## Explanatory note for power output versus frequency

EU Network Code Requirements for Generators (as per June 12, 2012), Art. 8.1.e):

Figure 1 : Requirements

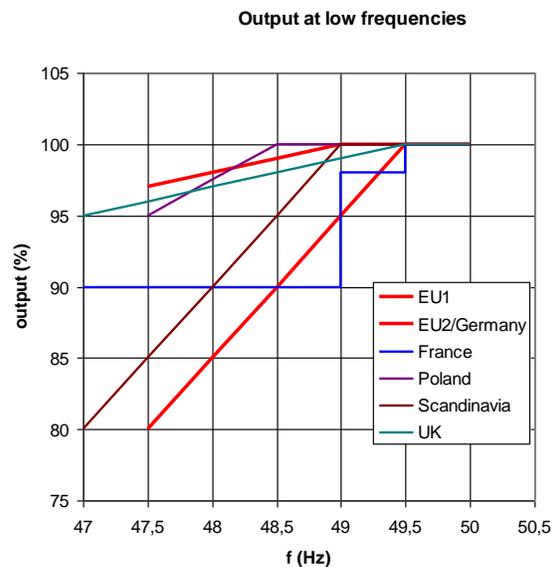
It has to be noted that in UK the current requirement is limited to an ambient temperature of 25°C and for CCGT modules to a time duration of 5 min in case frequency is below 48,8 Hz.

There exist furthermore some dynamic short term requirements (e.g. Germany, Austria and Hungary) to keep the plant on nominal output even if the frequency falls to 49 Hz (resp. 48 Hz in Austria) for a limited time (approx. 30 s).

This requirement therefore applies

- if a generating unit is operated at its current maximum output (which is depending on ambient conditions) without intrinsic output headroom
- under extremely disturbed conditions with a large drop of frequency when the system is not far from a total black out.

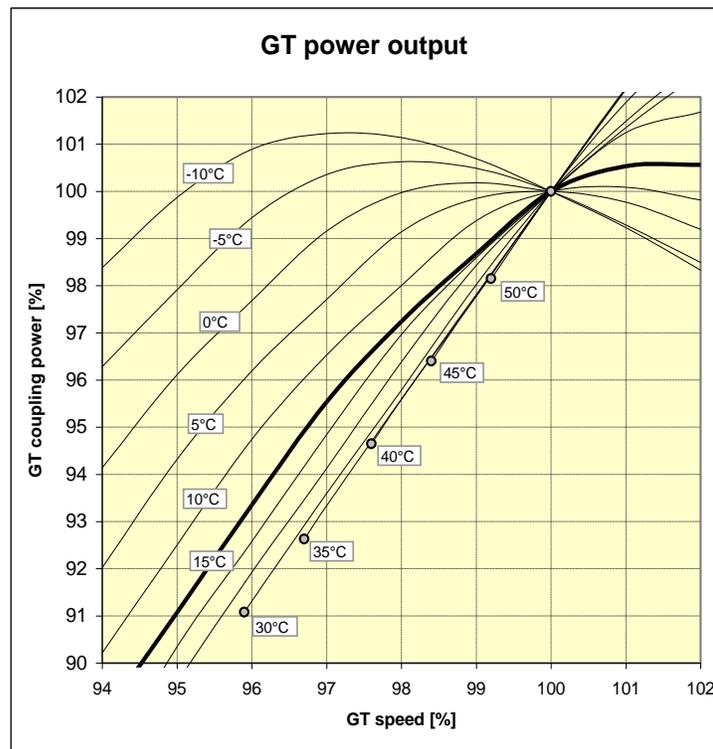
In contrast to e.g. a coal fired power plant, where steam generation is independent of the frequency (the small effect in the steam turbine at lower frequencies is negligible), a gas turbine shows a reduced air mass flow as a direct and immediate consequence of the decreasing grid frequency and hence the turbine rotational speed.

In addition, in order to have stable combustion conditions and not to risk any combustion disturbance with a consequent trip, the turbine outlet temperature is kept constant, adapting the fuel mass flow to the reduced air mass flow.

Both effects lead to a nearly immediate output reduction of the turbine in parallel to the frequency drop.

This behavior is highly nonlinear, and also strongly depends on the ambient conditions. If two parameters (in this case ambient temperature and frequency) deviate largely from design conditions, the effect is overlaid.

The following figure shows a typical behaviour of a utility size gas turbine (detail values depend on the individual machine), without any additional compensation features and without consideration of the Combined Cycle effect which reduces the output drop by approximately one third due to the virtually constant output of the steam turbine.

Additionally to the compressor thermodynamics, operation of the compressor is limited by the protection scheme against compressor pumping, which has to be avoided in any case and therefore limits the underfrequency operation at very high ambient temperatures.
